City of Detroit Inter-Departmental Communication

Petition No. 1006-revised

Request To Outright Vacate To And Convert To Easement The East/West And

The Detroit Water and Sewerage Department (DWSD) is in receipt of the subject petition. DWSD has sewers in the requested easement, and has no objections. However, DWSD also has water and/or sewer lines located within the area requested for outright vacation. The vacation request will be denied unless all the following conditions are met:

REQUEST TO OUTRIGHT VACATE
AND CONVERT TO EASEMENT
THE EAST/WEST AND NORTH/SOUTH
PUBLIC ALLEYS VARIOUS WIDTHS
IN THE BLOCK BOUND BY
ANTIONETTE, YORK ST., CASS AVE.
AND SECOND BLVD.

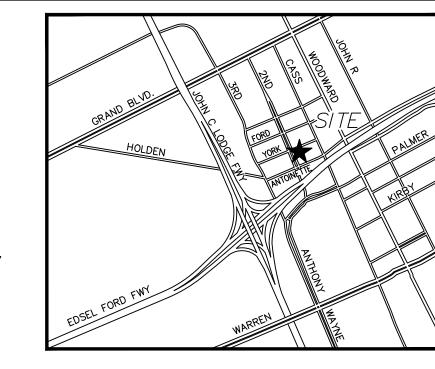
- Petitioner prepares a relocation plan for DWSD utilities, signed by a Registered
 Engineer
- DWSD approves the relocation plan;
- Petitioner grants DWSD a satisfactory easement;
- The Petitioner is to bear the entire cost of the proposed plan, including construction, demolition, permitting, inspection, survey, etc.

The entire work is to be performed in accordance with DWSD specifications and standards. Deposit with DWSD, in advance, the whole amount necessary to cover the costs of permits and inspection.
